DESIGN #	DRAWN BY SP	DART AEROSPACE LTD HAWKESBURY, ONTARIO, CANADA	
CHECKED #	APPROVED J	DRAWING NO. DEO 9157	REV. B SHEET 1 OF 1
DATE 99.10.21		TITLE DIMENSION CHANGE	SCALE NTS
A	99.07.12	NEW ISSUE (TSR A1227)	
B	99.10.21	CORRECT ERROR (0.500 WAS 0.625)

DART ENGINEERING ORDER

TO AMEND DRAWING D2750 REV. C

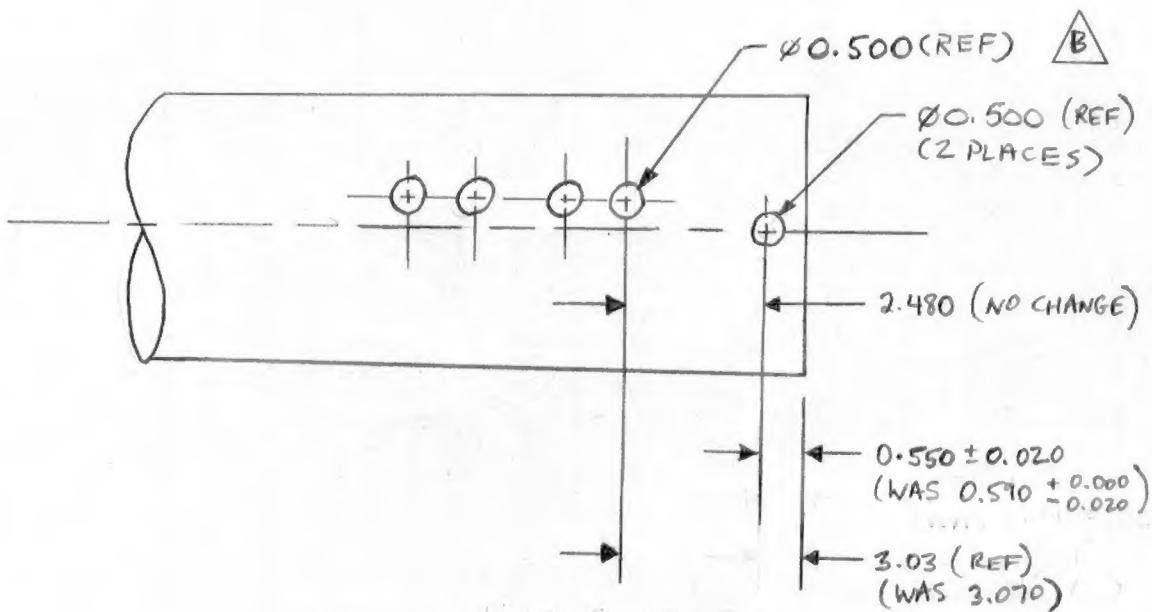
$\varnothing 0.500$ HOLES SHOWN ON PAGE 3 SHOULD BE LOCATED
 0.550 ± 0.020 FROM RFT END OF SKIDTUBE INSTEAD OF
 0.590 ± 0.020 (2 PLACES).

NOTE: OVERALL LENGTH OF TUBE IS NOW 112.48 (WAS 112.52)
